Informal document **GRRF-76-44**
(76th GRRF, 17 – 21 February 2014,
agenda item 5(a))

Proposal for amendments to Global Technical Regulation No. 3 (Motorcycle brake systems)

Submitted by the expert from Italy

<i>Conventional Brake System</i>	<i>Combined Brake System (CBS)</i>	
<i>Architecture A</i>	<i>Architecture B</i>	<i>Architecture C</i>

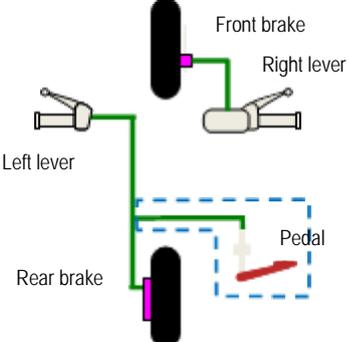
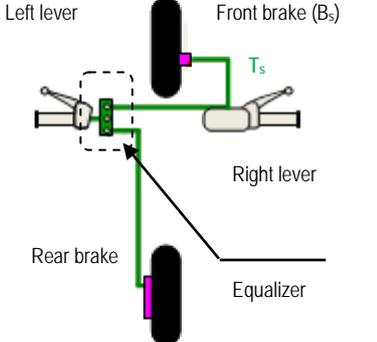
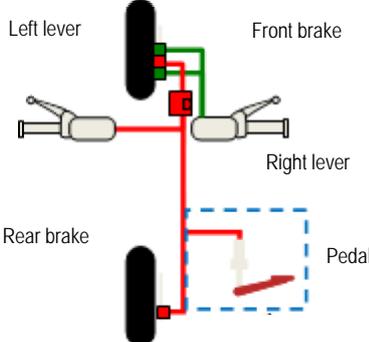
21. Architecture B is an example of a CBS that shares a transmission (T_s) and a brake (B_s).

22. While a failure in e.g. the "front system" (F_A) may affect the performance of the CBS, the rear system (operated by the left lever) will continue to be operational.

23. In order to ensure that, in case of a failure in one system, the performance of the other system still equals that of a conventional system, it is proposed to allow that two separate brake systems share a brake and/or a transmission, provided that the other system

meets the single brake system performance requirements in case of a failure of such shared components(s). To that end, a failure test is proposed for CBS brake systems of Architecture B. Italy is of the opinion that such a failure test requirement should ensure the acceptance of such a CBS in terms of demonstrated robustness and guaranteed minimum braking performance.

24. A failure test is not necessary for this type of CBS architecture because there are no shared components with the exception of a brake cylinder which is one of the components that are regarded to not be liable to breakage.

"3.1.9 In cases where two separate service brake systems are installed, the systems may share a common brake, ~~if a failure in one system does not affect the performance of the other~~ **a common transmission, or both if the requirements of paragraph 4.12 are met.**"

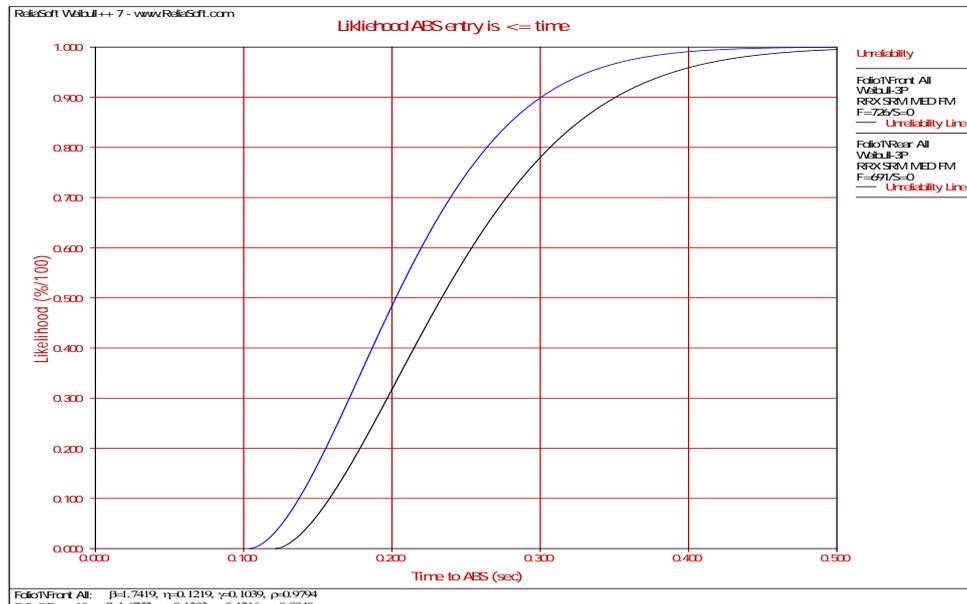
It has been noticed in testing that the brake application rate specified in paragraph 4.9.5.1 can result in a large number of test failures. It can be seen in the chart below that the 0.2 second lower limit shows a failure rate is between 30 per cent and 50 per cent of the time.

By reducing the lower limit to 0.1 seconds the test failure rate reduces to practically zero. Allowing the reduction tends to make the regulation more stringent by including a greater number of brake force application rates and eliminates restrictive test requirements.

The brake control actuation force is applied in ~~0.2~~ **0.1 – 0.5** seconds."
